REV.
G

AS21151™

RATIONALE

BEARING, BALL, ROD END, DOUBLE ROW,
PRECISION, EXTERNAL THREAD, SELF-ALIGNING,
AIRFRAME, TYPE II, -65 TO 300 °F

FIGURE 1 - PART CONFIGURATION

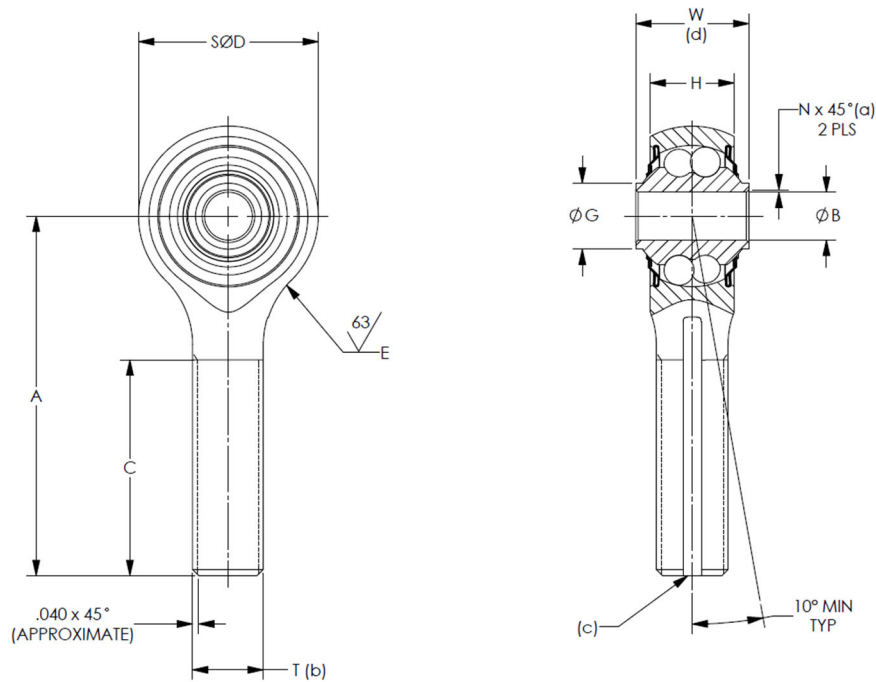
DOCUMENT UPDATED TO CORRECT FIGURE 1 PART CONFIGURATION "A" AND "C" DUE TO INCORRECTLY PLACED EXTENSION LINES AND CORRECT TABLE 1 MISSING DIMENSION IN COLUMN "A" FOR DASH NUMBERS 4 AND 5. TABLE 1 FONT INCREASED TO 8 PT FOR CLARITY. CADMIUM NOTE DEFINITION ADDED.
